# **Christmas Creek Expansion Public Environmental Review – Response to Public Submissions**

**Christmas Creek**

**25 September 2015  
CC-RP-EN-0120**

Figure 7 – Significant Vegetation Impacts within Proposed FMCR  
CC\_MP\_EN\_0263.005

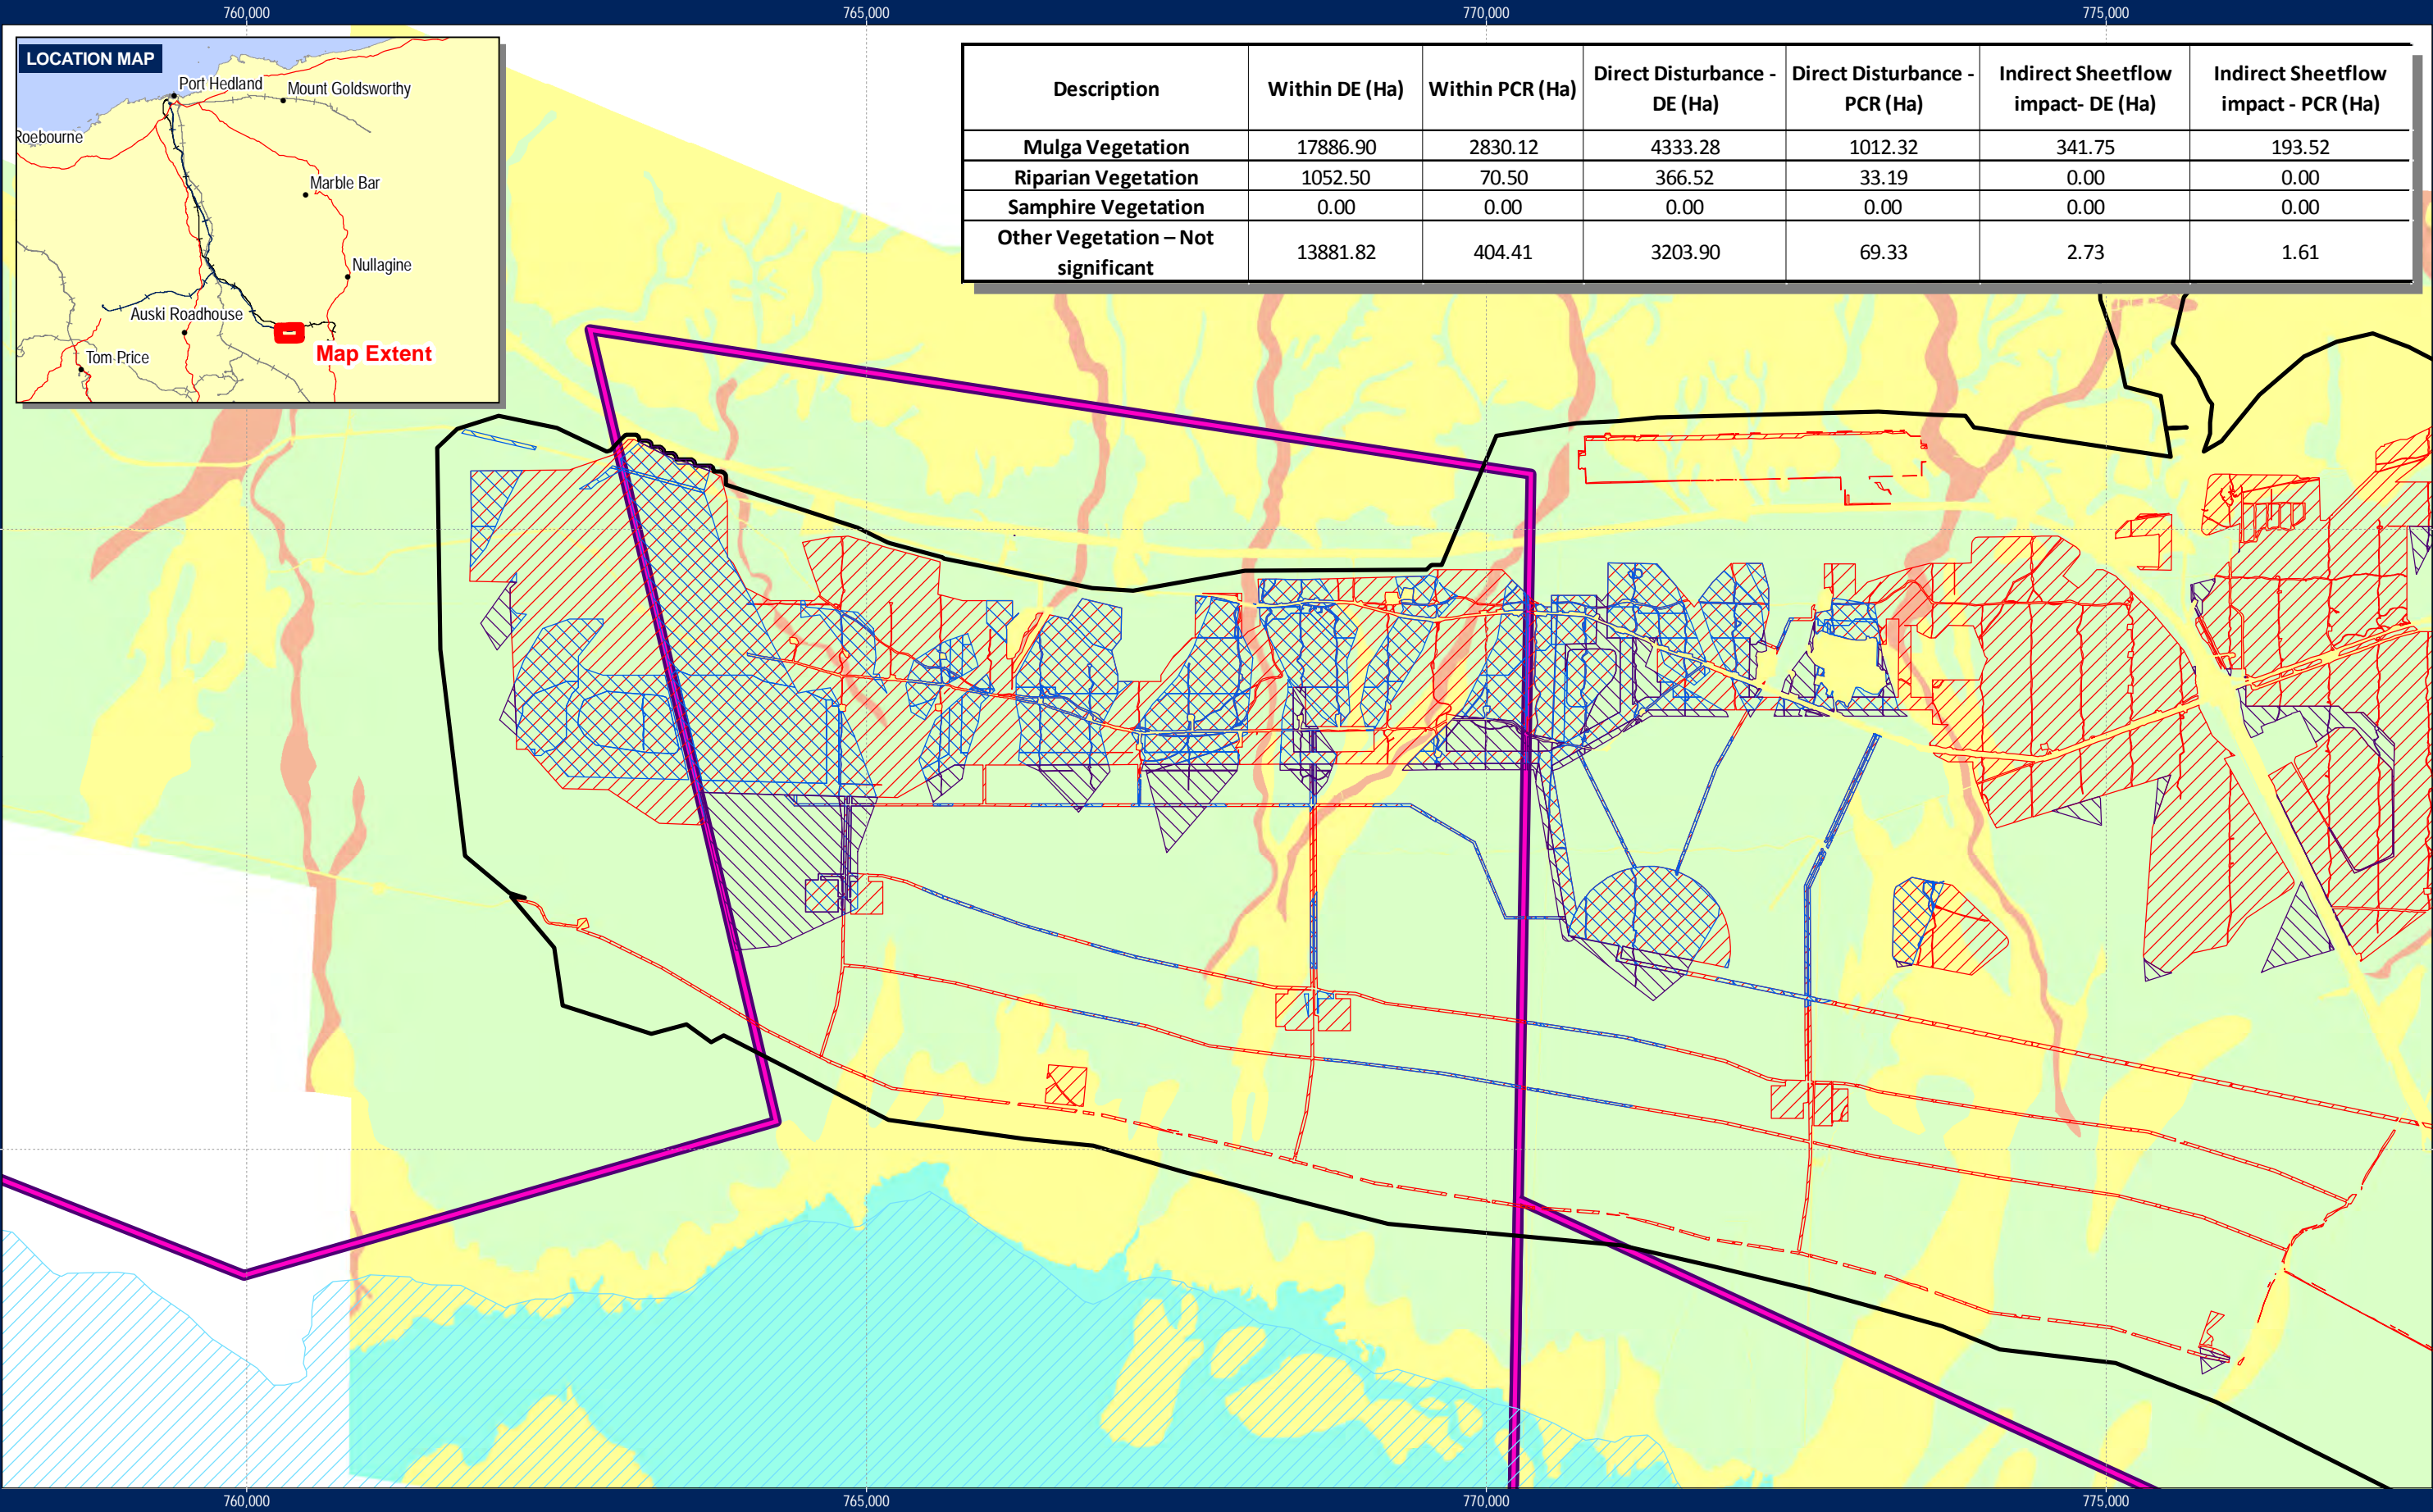
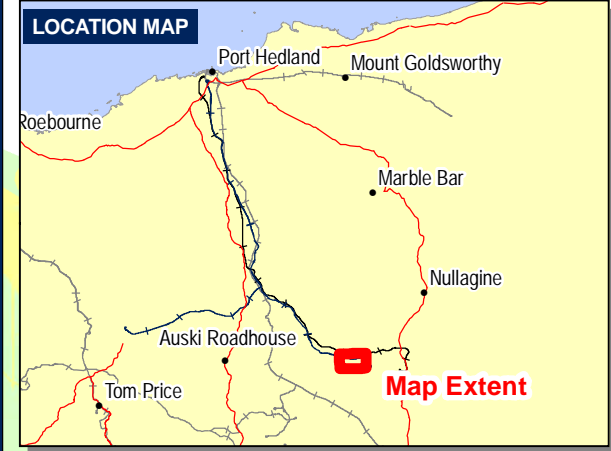
Item	Submitter	Submission and/or issue	Response to comment																																			
2.1	Department of Parks and Wildlife (DPaW)	<p>The Fortescue Marsh and the fringing mulga woodlands and samphire shrubland communities have been identified as a high priority for conservation reservation due to their significant habitat and specific conservation values, and their lack of representation in the existing reserve system. The proposed Christmas Creek Iron Ore Mine Expansion would affect additional areas within those sections of Roy Hill and Hillside pastoral leases that were identified in 2002 by Parks and Wildlife for exclusion from their respective leases in July 2015 so they could be included in the conservation reserve system. The information provided is not sufficiently detailed to determine the actual impact on these proposed reserve areas.</p> <p>Clear quantitative information should be provided on, the area of the specific vegetation types located within the proposed reserve areas that will be impacted.</p> <p>The proponent is yet to provide a clear estimate of the area and proportion of mulga in the 2015 pastoral lease exclusion area (north of the Fortescue Marsh) that will be impacted by mining. It appears from the information provided that the proposed direct and indirect impacts on the mulga communities to the north of the Marsh is likely to result in only a small proportion of mulga within the proposed reserve area north of the Marsh remaining uncleared.</p>	<p>Fortescue has undertaken additional analysis of the vegetation types an indicative disturbance inside the area of the proposed Fortescue Marsh Conservation Reserve (FMCR) that falls within the Proposal development envelope. Figure 7 (CC_MP_EN_0263.005) illustrates the vegetation units to be disturbed in the proposed FMCR. The indicative disturbance used for the analysis excludes the areas currently approved for disturbance under existing environmental approvals (MS707).</p> <p>Table iii summarises the direct and indirect disturbance to the vegetation types within the proposed FMCR. As detailed Fortescue estimates 1,205.84 ha of Mulga will be directly or indirectly impacted within the proposed FMCR area intersected by the Proposal. This represents 42.6% of the mulga vegetation within the portion of proposed FMCR within the Proposal boundary.</p> <p><b>Table iii: Analysis of vegetation disturbance with proposed Fortescue Marsh Conservation Reserves (FMCR).</b></p>

Figure 8 – Revised Proposed FMCR boundary CC\_MP\_EN\_0263.004

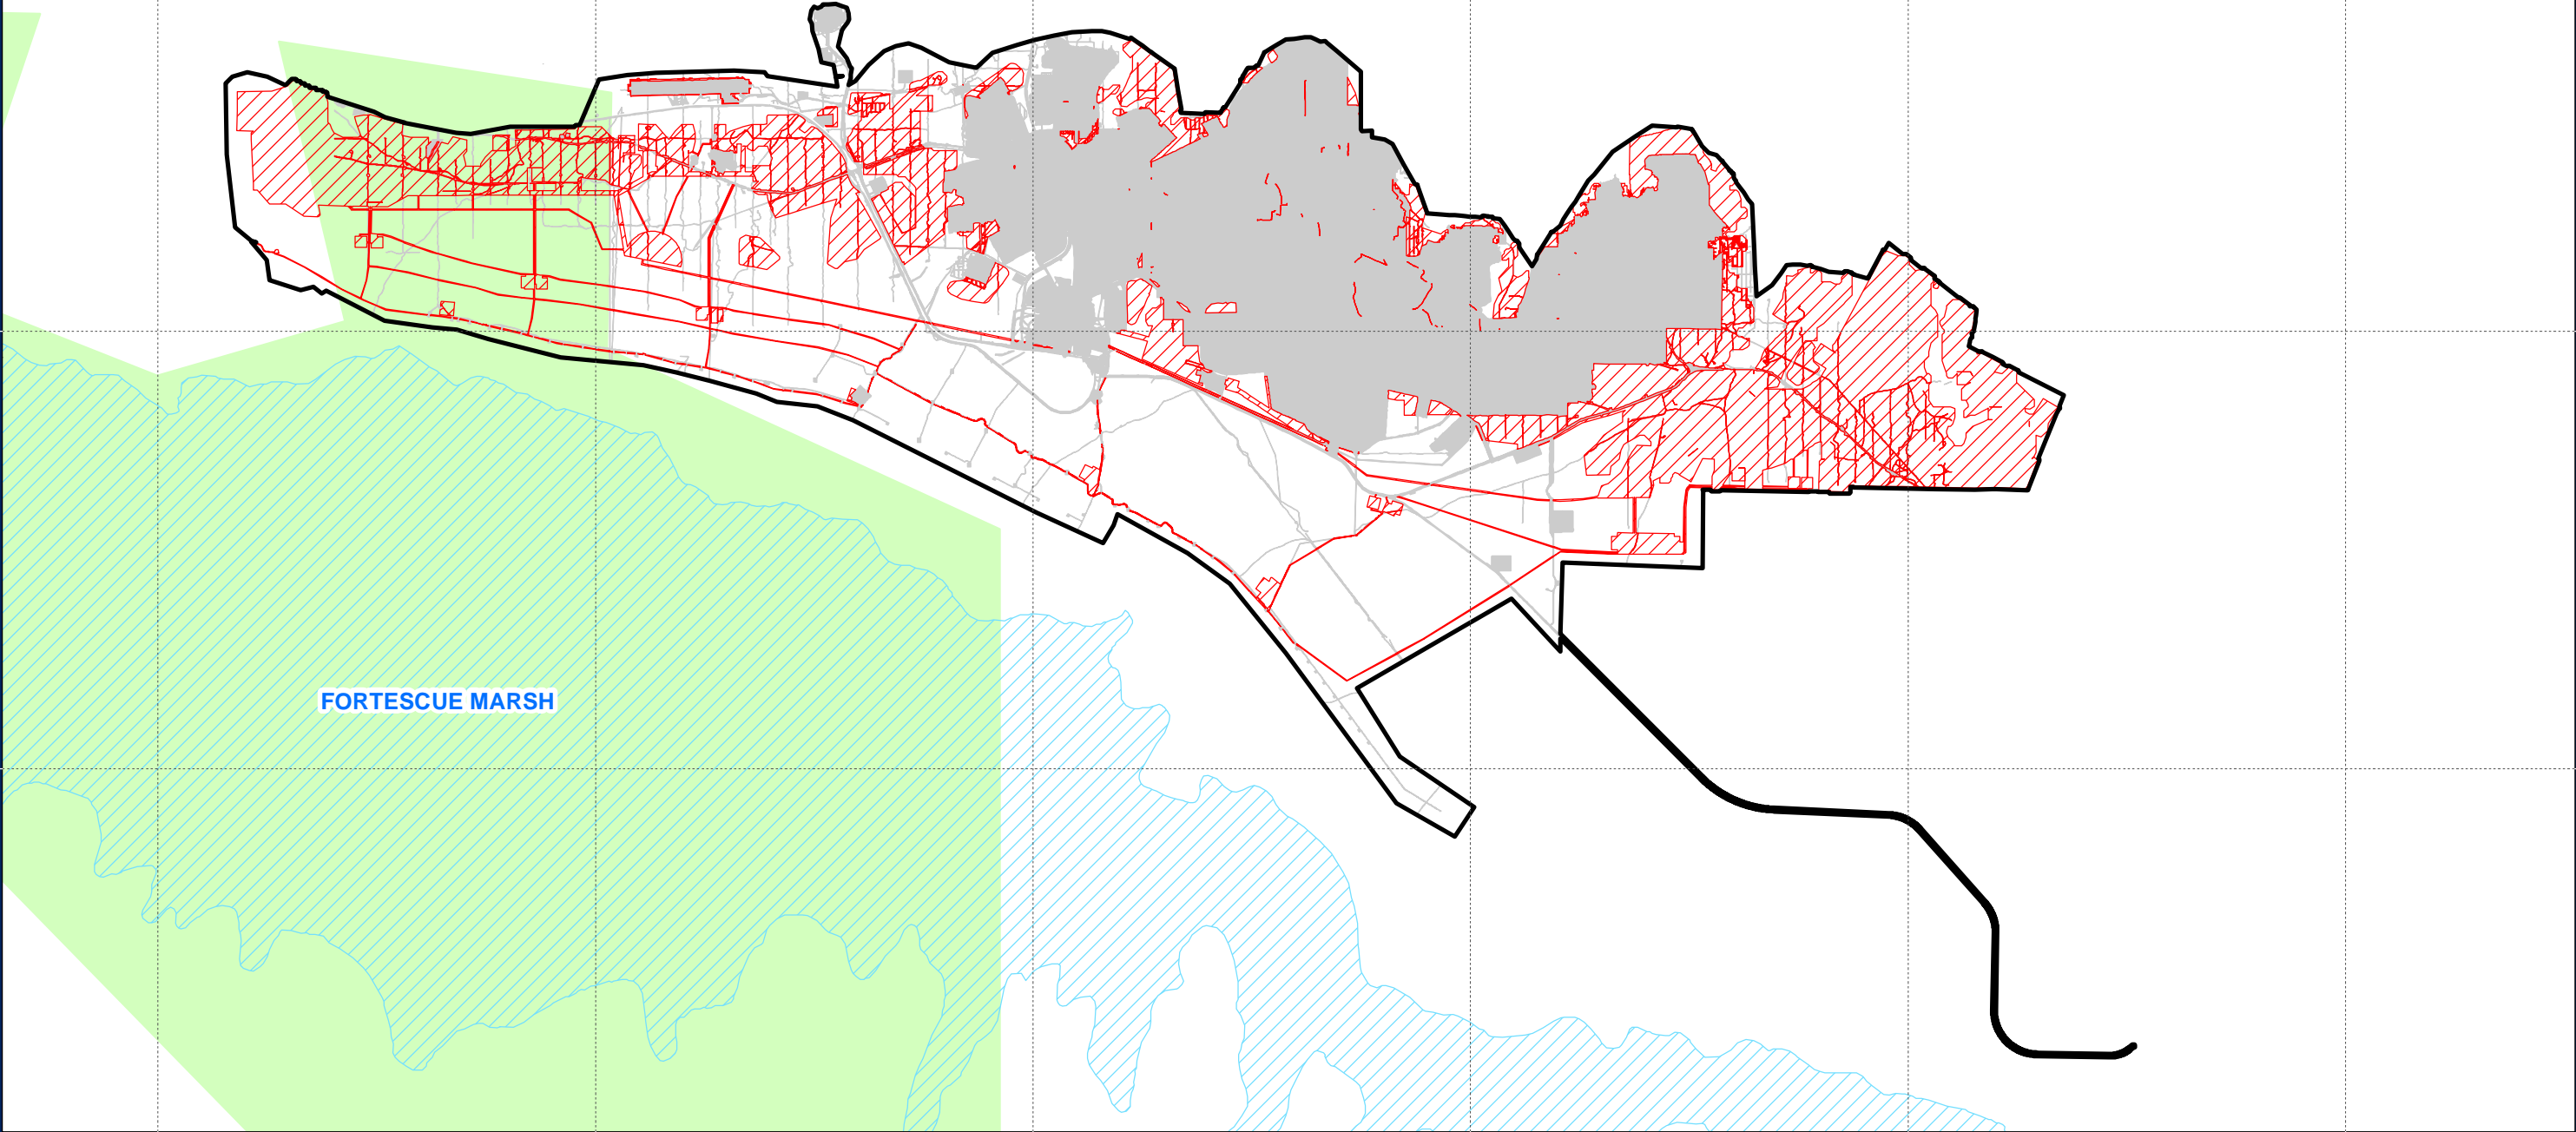
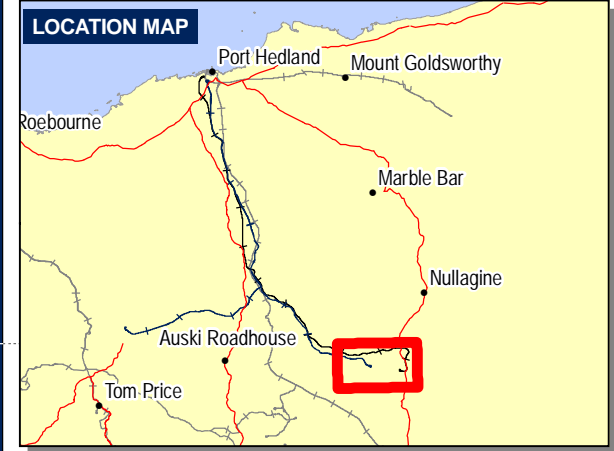
Item	Submitter	Submission and/or issue	Response to comment																																								
2.2		Further information is required to illustrate that all viable alternatives regarding the selection of prospective orebodies and the design and location of infrastructure for the expansion project have been considered in order to minimise impacts on the values of the proposed Roy Hill and Hillside conservation reserve.	<p>Fortescue understands that on 1 July 2015 some areas within the Roy Hill and Hillside pastoral leases will be relinquished. The tenure of these relinquished areas will return to Unallocated Crown Land (<b>UCL</b>) with the existing overlapping <i>Mining Act 1978</i> tenure to remain. It is understood that DPaW wishes to convert the relinquished UCL into the proposed Roy Hill and Hillside conservation reserves.</p> <p>Fortescue has reviewed the Christmas Creek Expansion proposed disturbance with the area of the proposed conservation estate. It has been identified that Figure 46 provided in the PER depicting the intersection of the Christmas Creek Expansion (the Proposal) with the proposed conservation estate is incorrect. The boundary used for the Proposed Fortescue Marsh Conservation Reserve (FMCR) was a boundary provided by the Department of Lands in 2011. An updated proposed boundary of the area to be relinquished from Roy Hill Station was provided by the Department of Lands in mid-2014. The revised boundary reduces the size of the proposed FMCR and reduces the area intersected by the Proposal.</p> <p>Fortescue has undertaken further analysis of the impacts of the Proposal on the areas within the proposed FMCR. Figure 8 (CC_MP_EN_0263.004) attached details the revised intersection of the Proposal with the amended FMCR boundary. Section 9.7.1 (pg. 146) of the PER outlines the direct disturbance inside the proposed FMCR associated with the Proposal. Following the analysis of the disturbance using the 2104 Department of Lands boundary Fortescue has prepared Table iv below.</p> <p><b>Table iv: Direct Disturbance associated with the proposed Fortescue Marsh Conservation Reserve (FMCR).</b></p>

<p>^Please note there is some overlap in the indicative disturbance areas as miscellaneous infrastructure, tailings storage and work rock facilities can be constructed over mined out pits.</p> <p>The revised boundary reduces the area of the proposed FMCR intersected by the Proposal to 3,305 ha or approximately 10% of the Proposal. As detailed in Table iv the proposed direct disturbance inside the proposed FMCR is limited to Mine Pits and Miscellaneous Infrastructure (e.g. roads, pipelines, topsoil storage areas etc.), approximately 6% of the Proposal disturbance is located within the proposed FMCR. This disturbance is dependent on the location of the ore body and suitable geology for reinjection of groundwater. Optional disturbance (e.g. waste rock storage facilities, remote crushing hub and tailings facilities etc.) have been located outside the boundary of the proposed FMCR to minimise the direct disturbance inside the proposed FMCR (refer to Figure 7).</p>	Description	Inside development envelope and inside Proposed FMCR (ha)	Inside development envelope but outside Proposed FMCR (ha)	Total Inside 33,000 ha development envelope (ha)	Percentage inside Proposed FMCR of Total Proposal (ha)	Area of Proposed FMCR inside development envelope	N/A	N/A	3,305.03	10%	Existing approved footprint (MS 707)	88.51	11,432.18	11,520.69	1%	Indicative Mine Pits	492.37	12,308.17	12,800.54	4%	Indicative Miscellaneous Infrastructure	673.14	4,085.56	4,758.70	14%	Indicative Tailings Storage	0.0	192.65	192.65	0%	Indicative Waste Rock Facilities	0.0	2125.68	2125.68	0%	Total Indicative Disturbance^	1,165.11	18,712.06	19,877.57	6%
Description	Inside development envelope and inside Proposed FMCR (ha)	Inside development envelope but outside Proposed FMCR (ha)	Total Inside 33,000 ha development envelope (ha)	Percentage inside Proposed FMCR of Total Proposal (ha)																																							
Area of Proposed FMCR inside development envelope	N/A	N/A	3,305.03	10%																																							
Existing approved footprint (MS 707)	88.51	11,432.18	11,520.69	1%																																							
Indicative Mine Pits	492.37	12,308.17	12,800.54	4%																																							
Indicative Miscellaneous Infrastructure	673.14	4,085.56	4,758.70	14%																																							
Indicative Tailings Storage	0.0	192.65	192.65	0%																																							
Indicative Waste Rock Facilities	0.0	2125.68	2125.68	0%																																							
Total Indicative Disturbance^	1,165.11	18,712.06	19,877.57	6%
